**Item #2:**  
**Report Of The December 20, 2010 AC Meeting**  
**A. Long Grove Community Church - Sign**

**AGENDA**  
**ARCHITECTURAL COMMISSION**  
**REGULAR MEETING**  
Monday, December 20, 2010 at 7:00 P.M.

TO: Village President and Village Board  
FROM: James M. Hogue, Village Planner  
DATE: January 4, 2011  
RE: Board & Commissions Report for 1/11/11

### **AB; 12.20.10 – 5 Action Items**

PER: NORTH SHORE SIGN  
Drawing #D8827

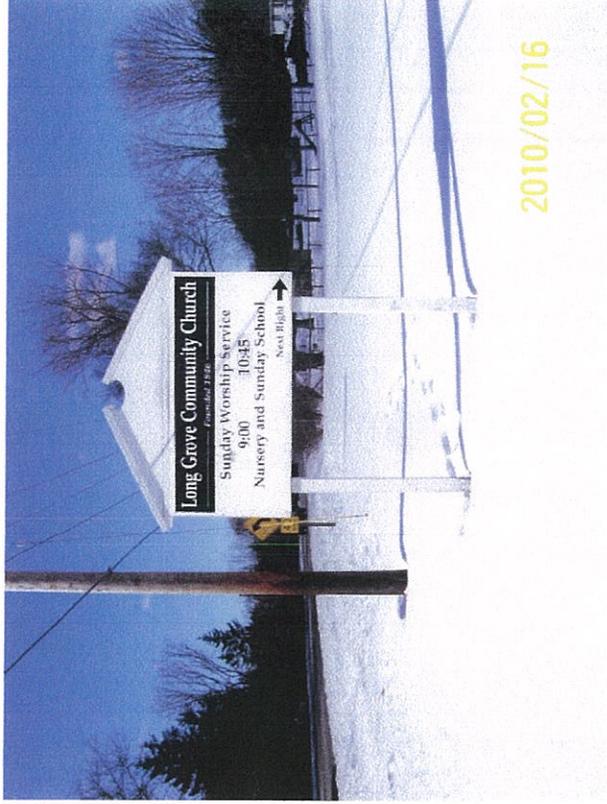
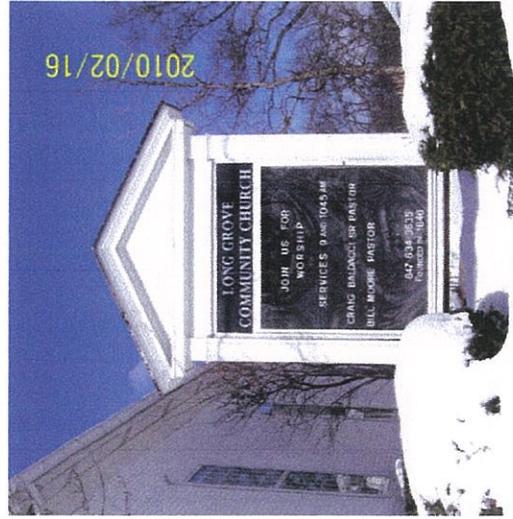
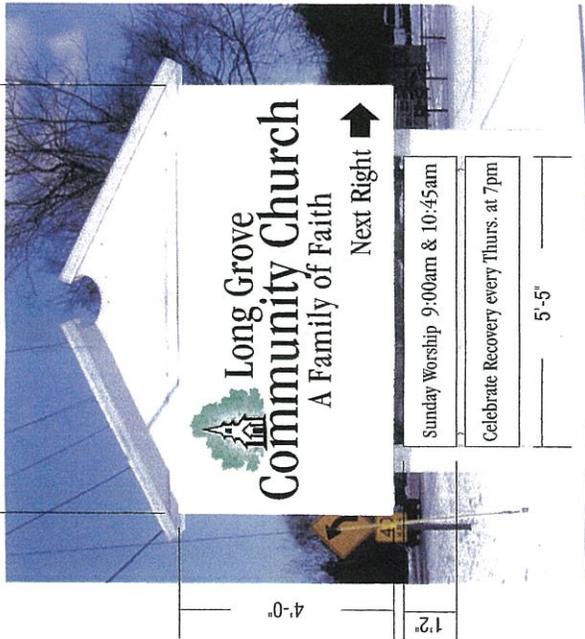
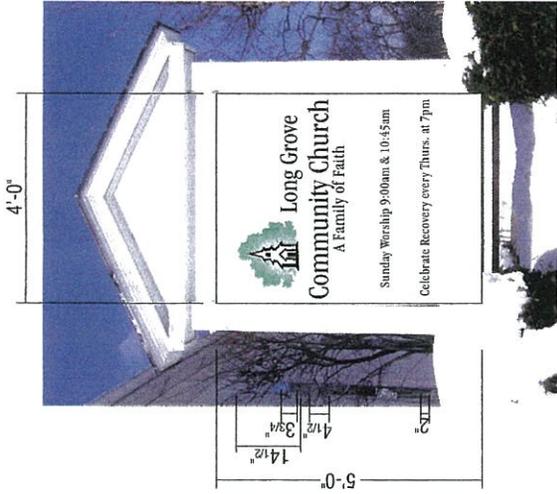
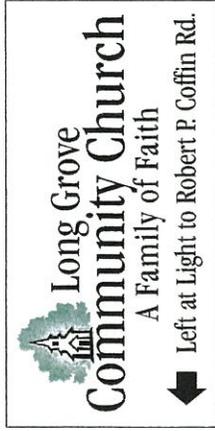
The AC liked the look of the sign but noted that the times on the "riders" may need to be modified from time to time should times of worship change.

A motion was made by Commissioner Connolly, seconded by Commissioner Calas, to accept the signage as submitted with the condition that minor changes to the to the "riders" (such as the time of fellowship or worship) may be changed without further AC review provided the square footage of the signage is not altered. On a voice vote, all aye.

**RETAIL 'E' WEST ELEVATION**

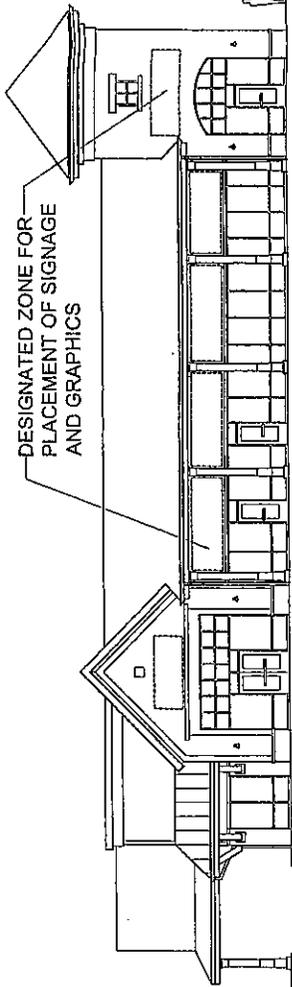
The AC liked the look and color selection for the proposed signage. A motion was made by Commissioner Connolly, seconded by Commissioner Brockman to accept the signage for “SportClips” on “Building E” within the Sunset Grove development as proposed. On a voice vote, all aye.

**REVISED ELEVATIONS**  
**OPTION 'A' with SPANDREL GLASS**

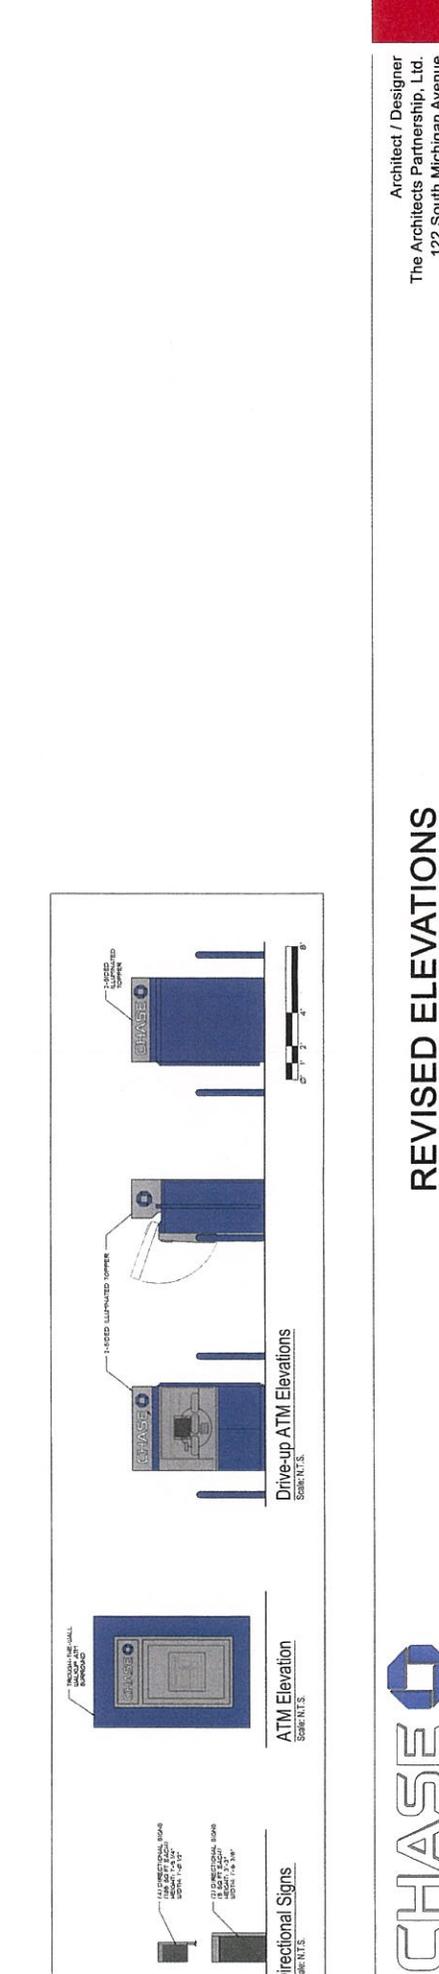
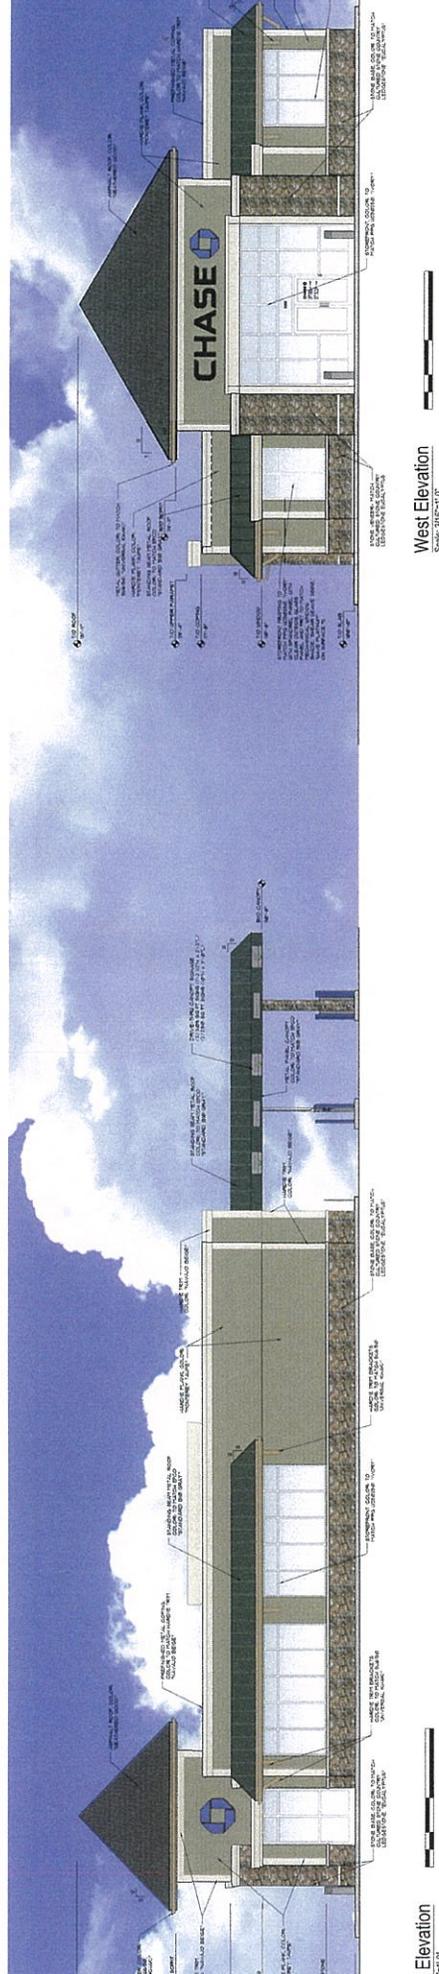
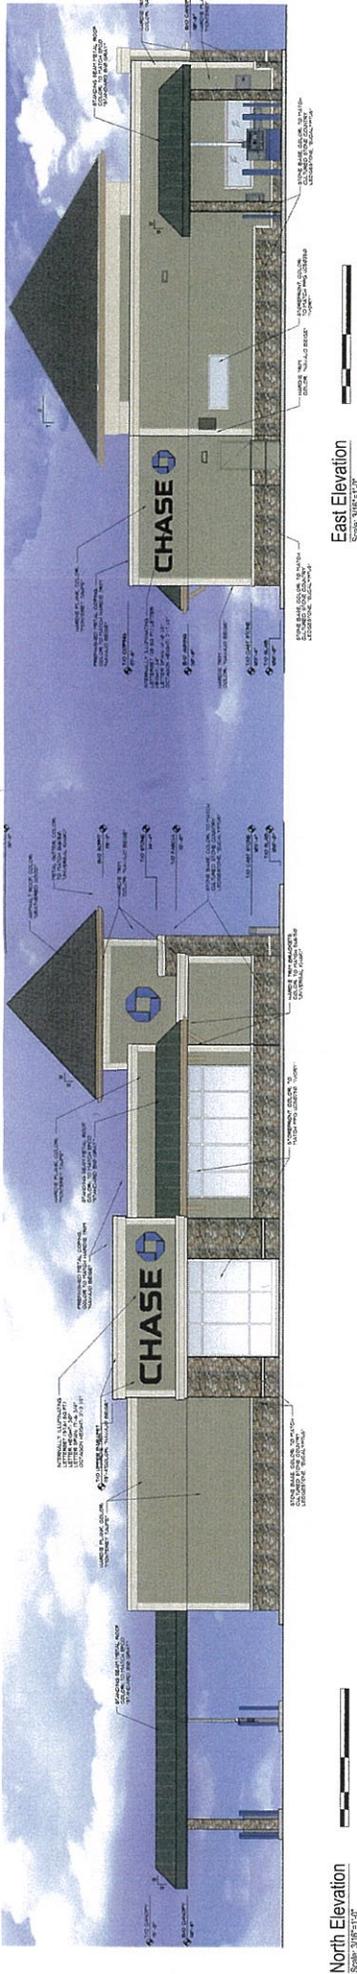
After discussion concerning modifications to the interior of the structure and exterior aesthetics of the building façade, the AC requested modifications to “Option A” as follows;

- Spandrel Glass window panes be placed in the “bump out” room housing the safety deposit boxes.
- The glass color is to match the color of the shades in the building.
- An amended elevation be submitted identifying the changes to the elevation (See attached “Revised Option A”).
- The amendments are subject to staff review for conformity to the AC recommendation.

A motion was made by Commissioner Tapas, seconded by Commissioner Calas, to accept modification to the approved elevations of the proposed Chase Bank Building within the Sunset Grove Development subject to the conditions as discussed (identified above). On a voice vote; all aye

1 ROUTE 83 - WEST ELEVATION  
SCALE: 1/8" = 1'-0"

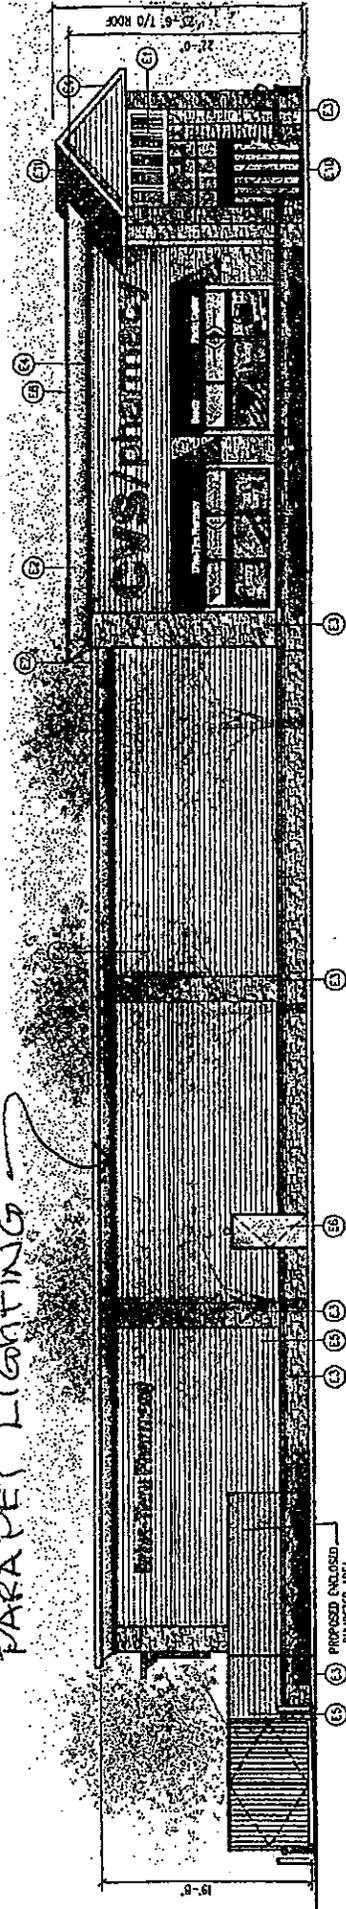
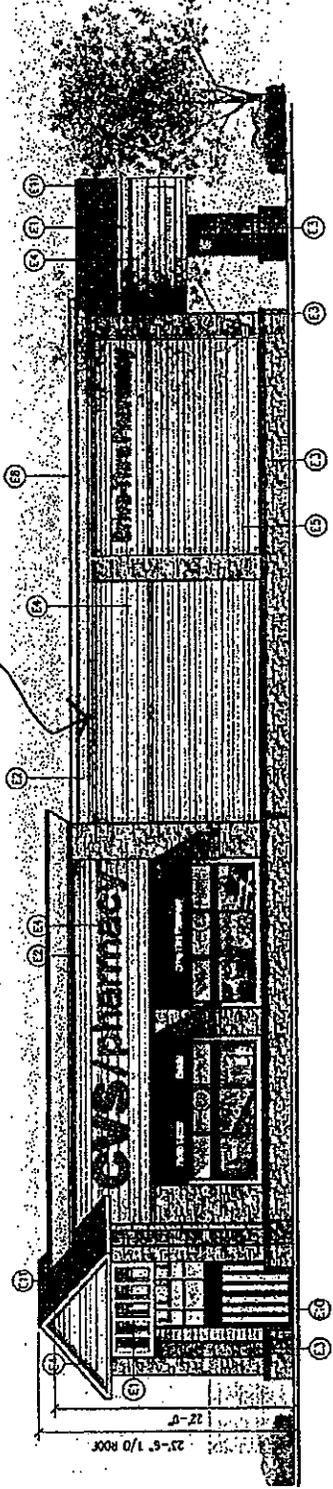
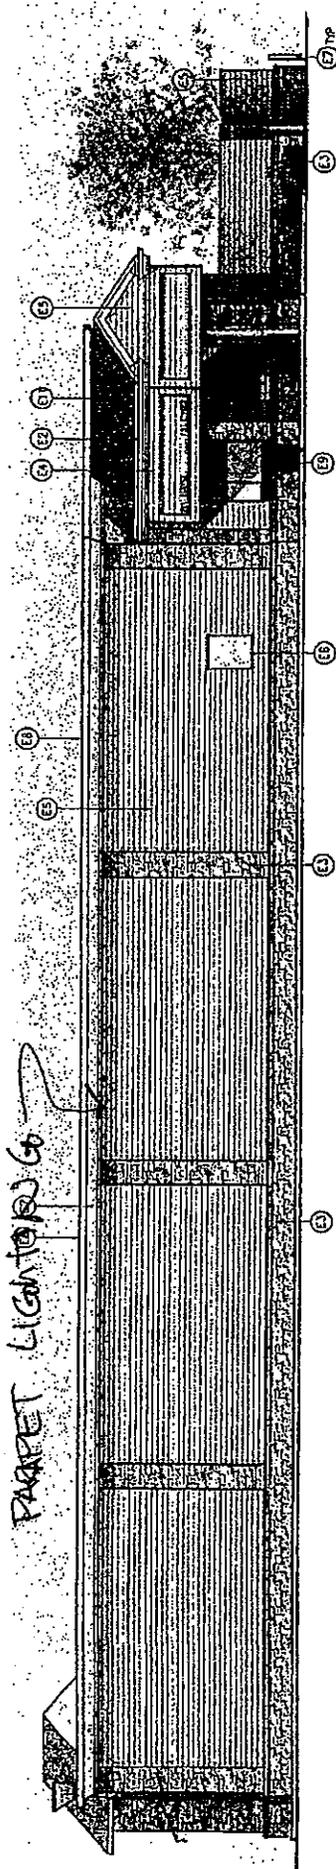
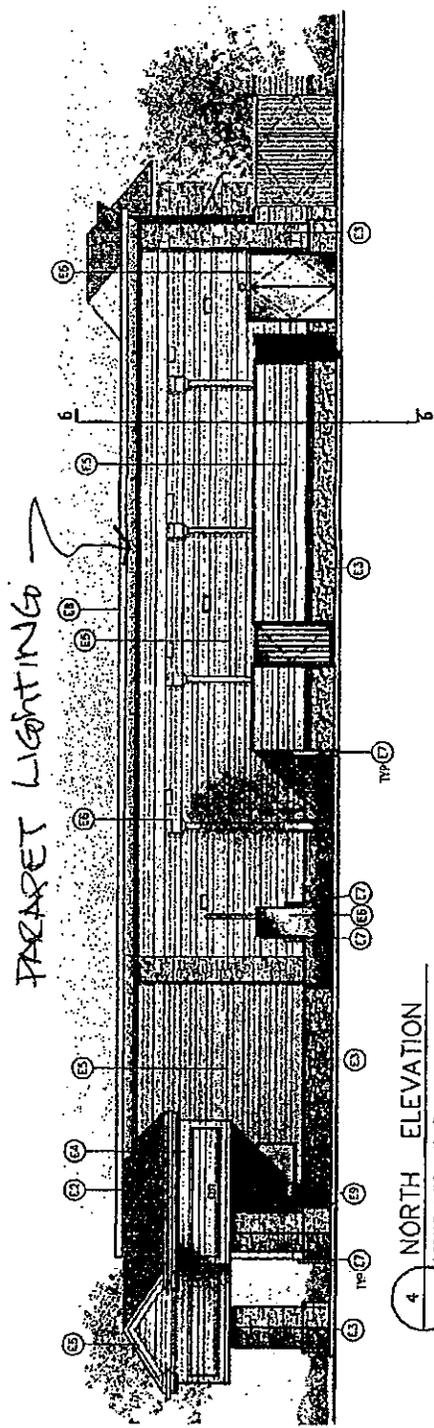
After discussion the AC was concerned that this type of lighting would set a precedent for other commercial structures in the Village and particularly within the Sunset Grove Development. It was further noted that this lighting does nothing but outline the building. Given the overall lighting plan for the development this building lighting is not necessary.

A motion was made by Commissioner Connolly, seconded by Commissioner Tapas **not to accept** the retroactive request for the building lighting on the CVS Building within the Sunset Grove development and the lighting be kept turned off at all times and/or removed entirely from the building facade. On a voice vote, all aye.
